Symmetry Park, Knowsley, Merseyside

Response to Knowsley Council Highways Comments

VN212041

Phase 2, Symmetry Park,
Merseyside
Unit 2 - Cycle Shelter

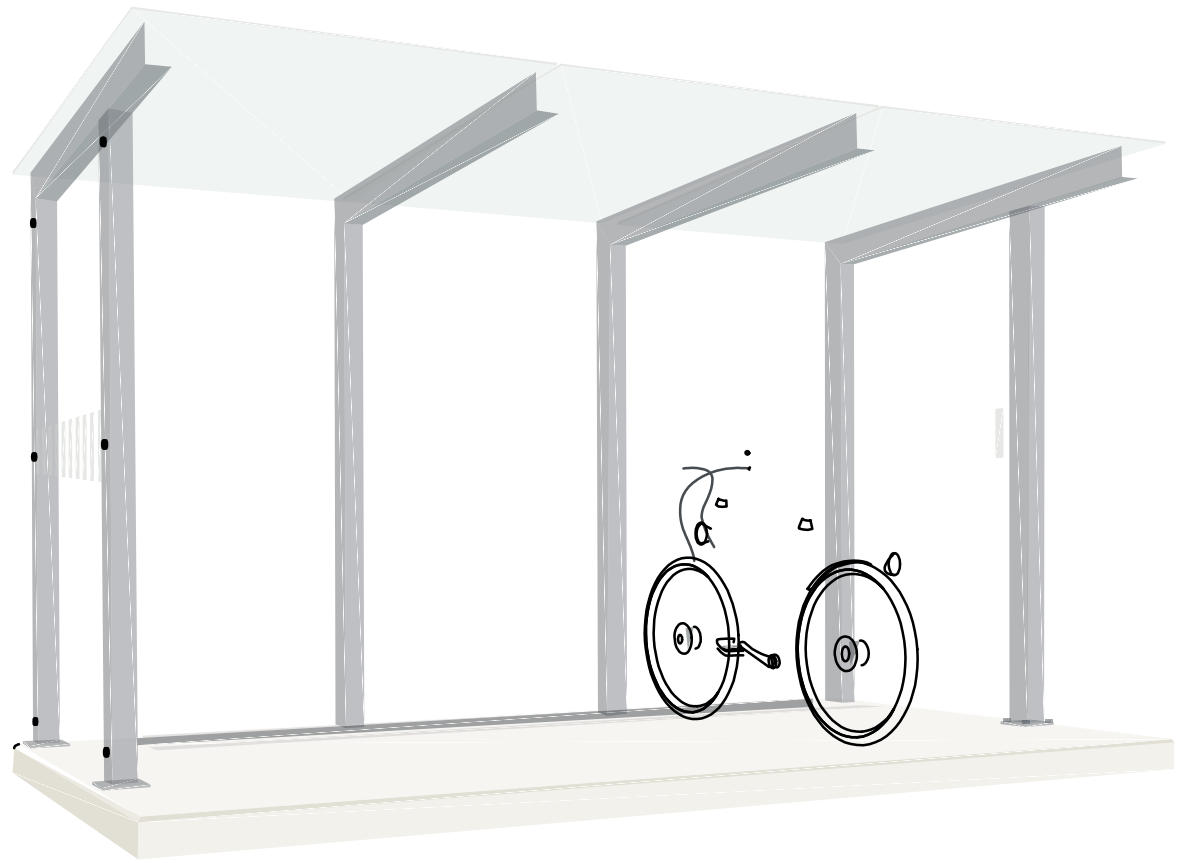
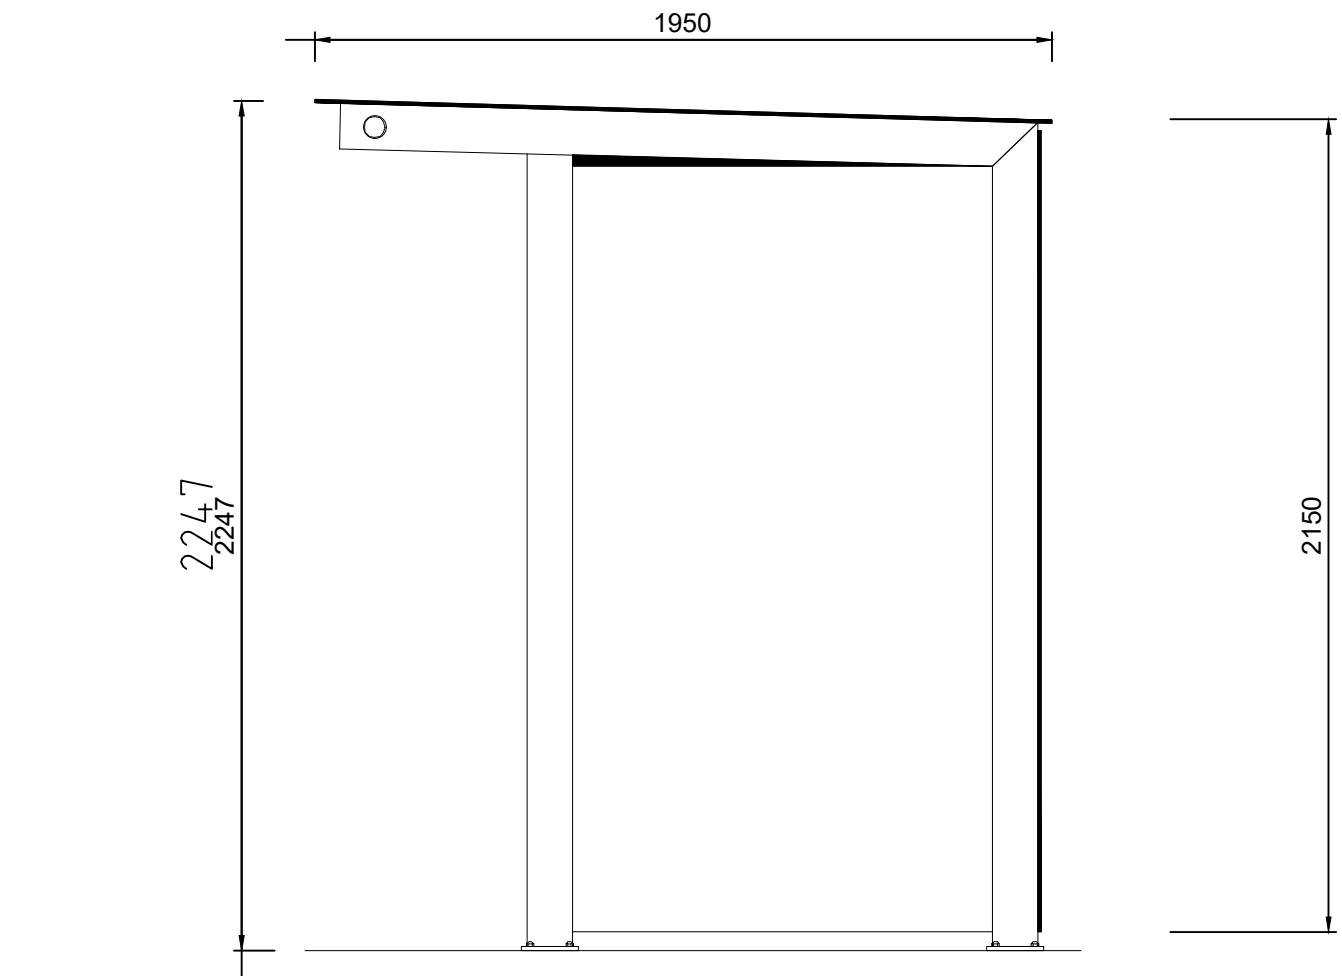
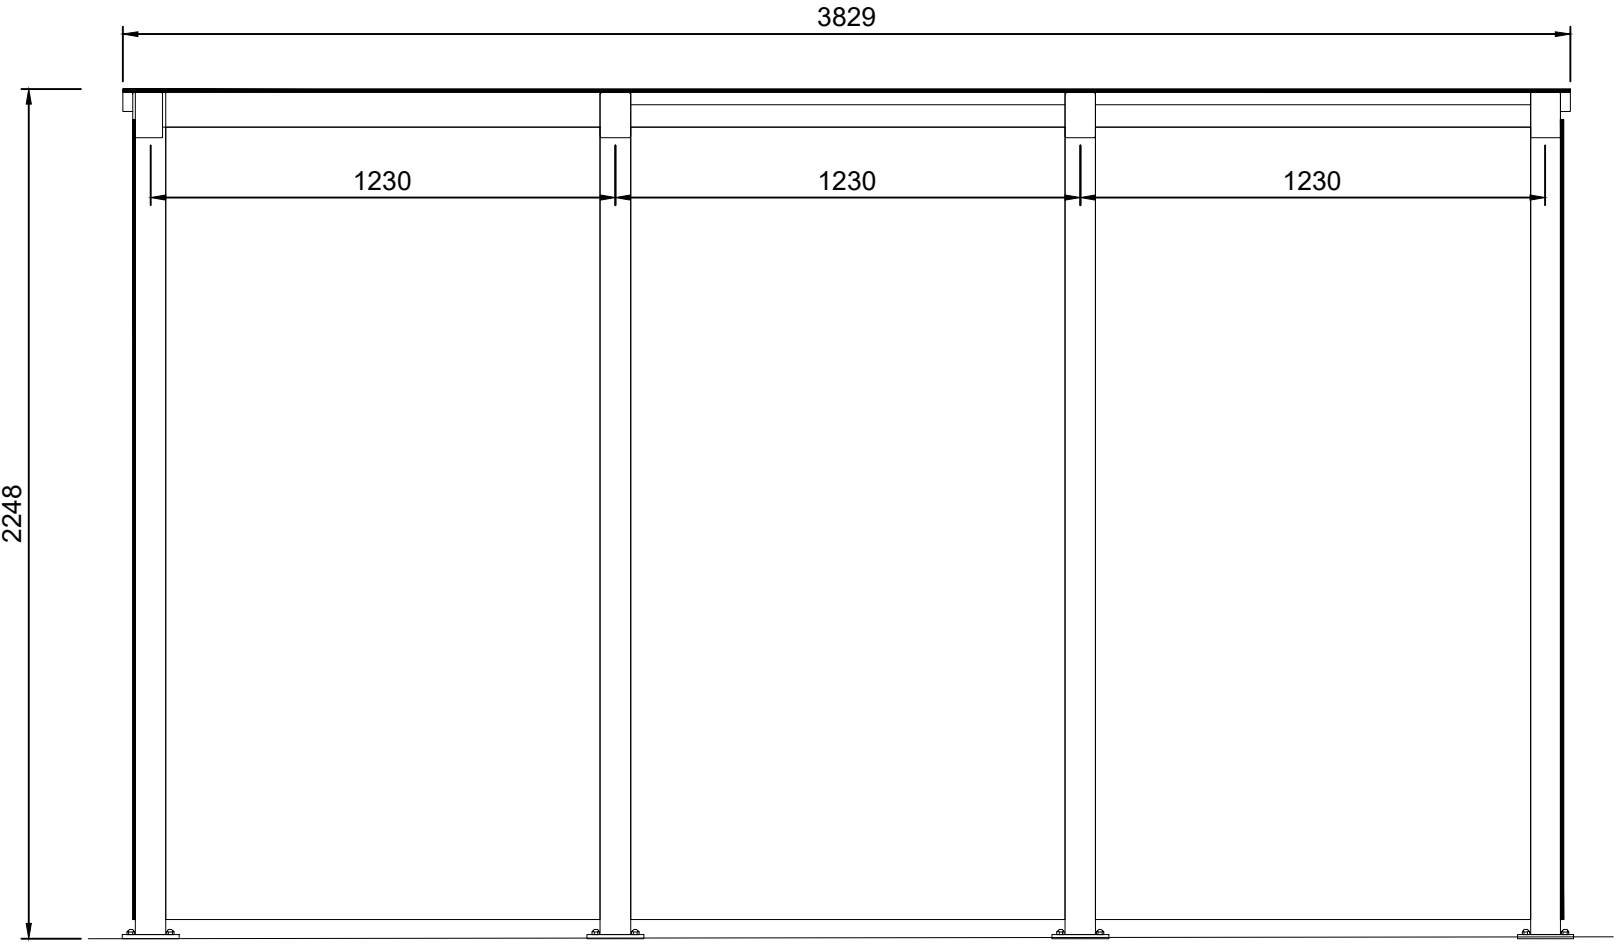
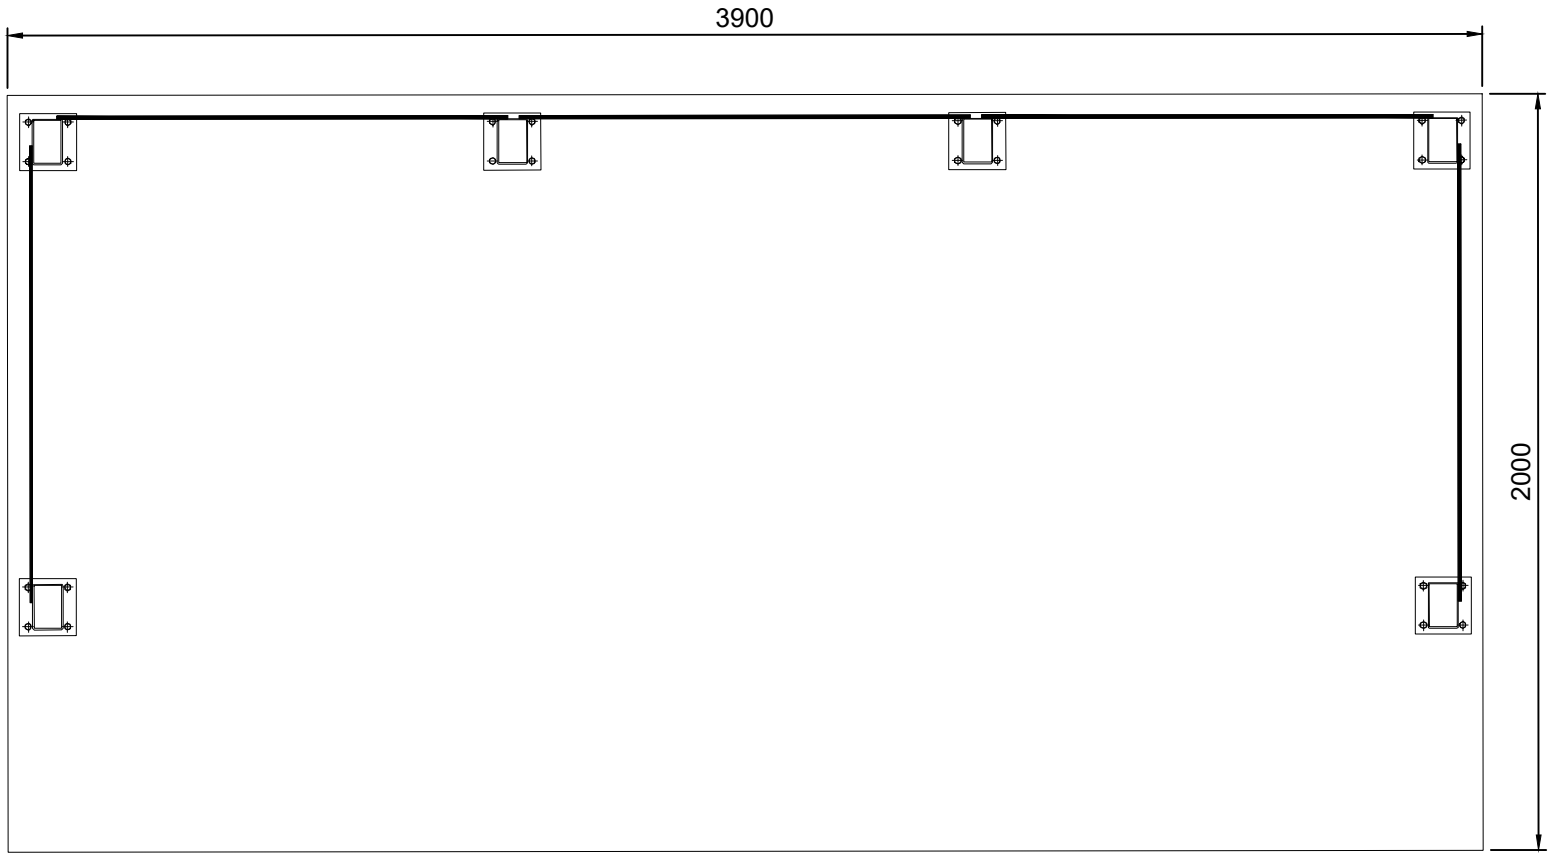
The cycle shelters themselves do not appear to have any means of securing the bicycles themselves. This will need to be clarified.

10. The cycle shelter for Unit 2 will provide hoops for securing bicycles in line with the occupier's own specification for cycle parking at their sites, and a plan showing the proposed cycle shelter details is included as **Appendix B.**
